March 6, 2009
 Subject: **York Weigh Station**
 Federal Project No. IM-1162(300)E
 State Pin No.011623.00
Amendment No. 1

Make the following changes to the Bid Documents:

POWER RISER DIAGRAM

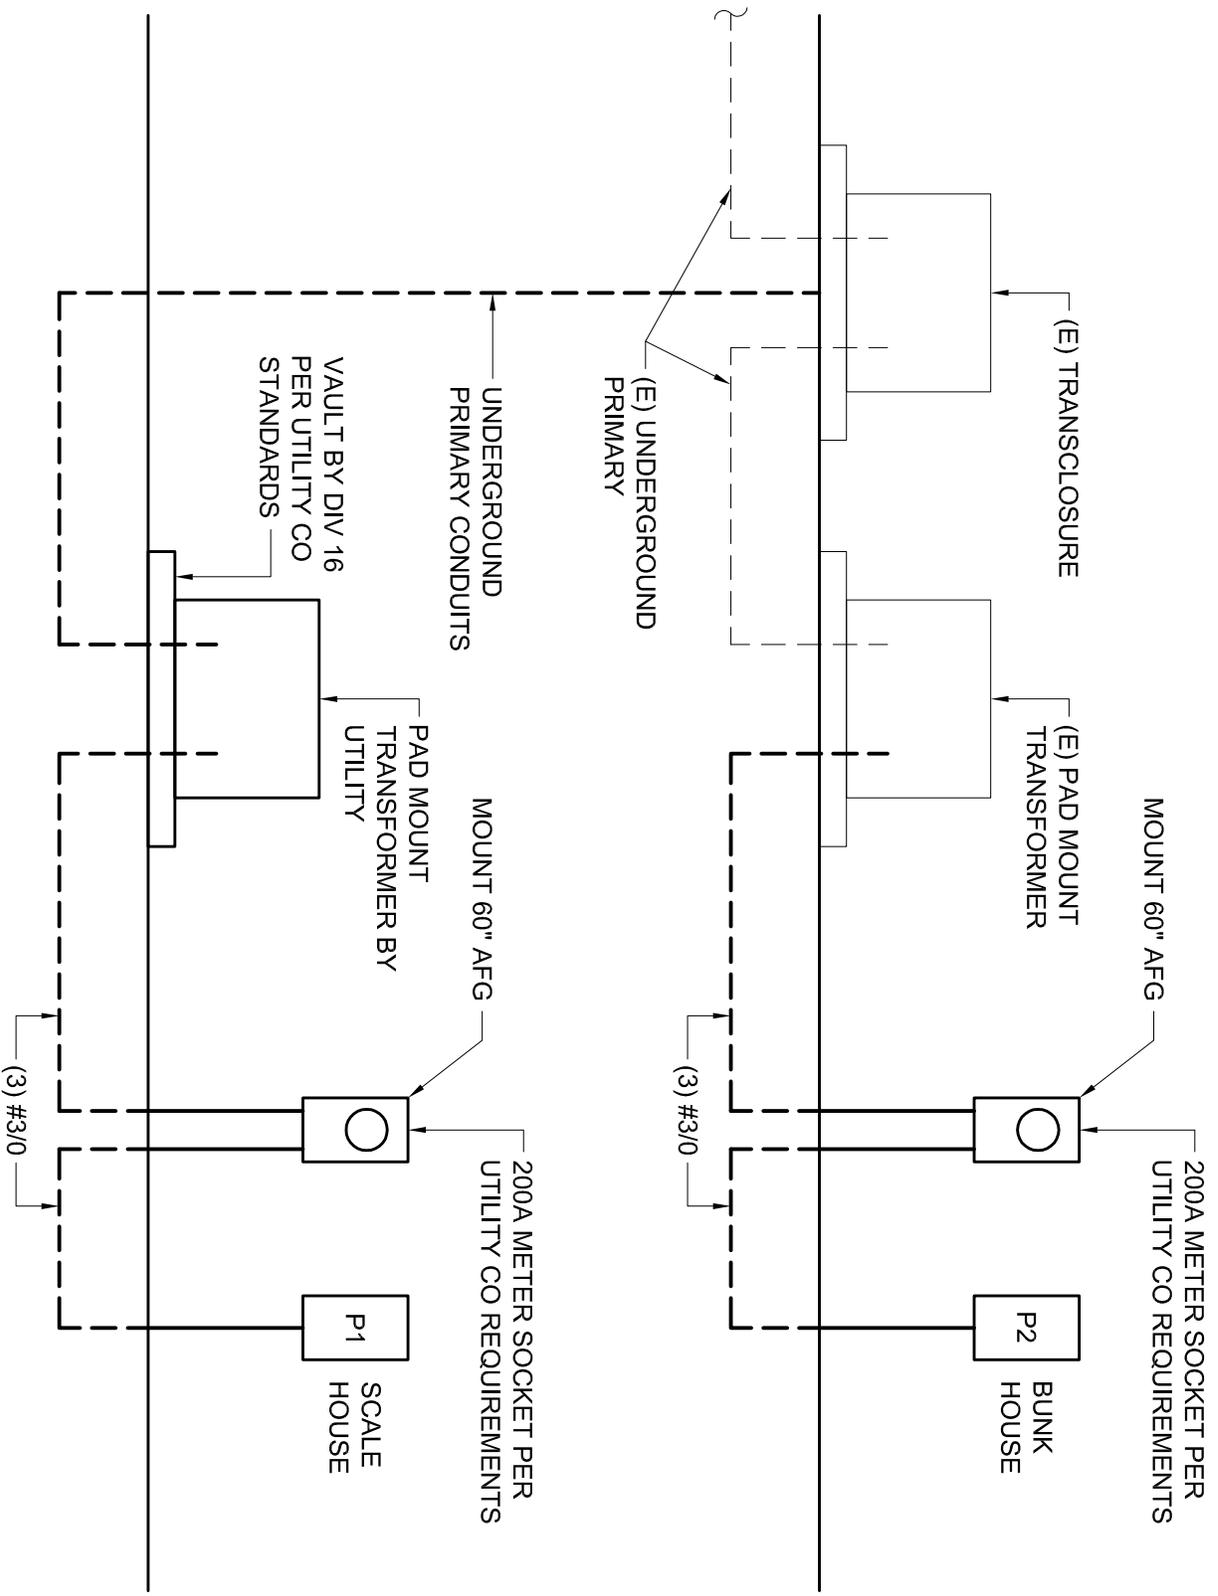
Question: Prints E-101 and E-100 do not show meter location or type. If not mounted next to the panel, CMP will most likely require meter disconnect style with 200 amp breaker. No disconnects are shown at CU-1 thru CU-3.

Response: Refer to "Changes to the Drawings" below regarding metering. Disconnect switches for the condensing units are indicated on the Electrical Schedule of Mechanical

SKE-02

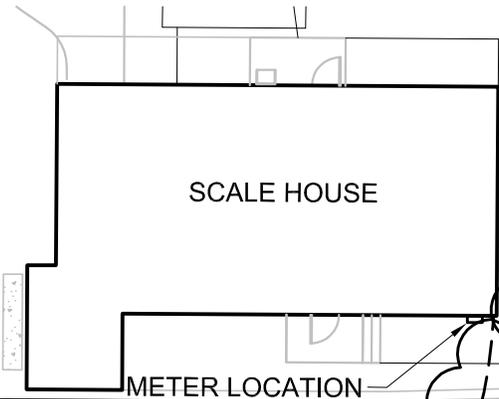
- A. DRAWING ES-100
 1. Detail A5: **ADD** pole light description as indicated on Sketch SKE-02.
- B. DRAWING ES-102
 1. Refer to Sketch SKE-02 for electricity meter socket location.
- C. DRAWING ES-103
 1. Refer to Sketch SKE-02 for electricity meter socket location and revised pole light location.
 2. **DELETE** Key Note 5. **ADD** in its place: “Wire and connect pole lights to circuit P1-9 using (2)#12+(1)#12G via a photocell and 2-pole switch wired in series. Locate the photocell beneath the eave on the North side of the building. Locate the 2-pole switch on the West wall of room Platform 108.”
- D. DRAWING E-000
 1. **ADD** Power Riser Diagram as indicated on Sketch SKE-01.
 2. Detail A1: At Luminaire Schedule, **DELETE** luminaire type F. **ADD** in its Place luminaire type G as follows:

METER LOCATIONS
RELOCATE POLE LIGHT

POLE MOUNTED FLOOD LIGHT ~ HUBBELL OA-P400-12-MT-VG-PS
WITH 400W PULSE START METAL HALIDE LAMP ON 25' TAPERED
ROUND STEEL POLE
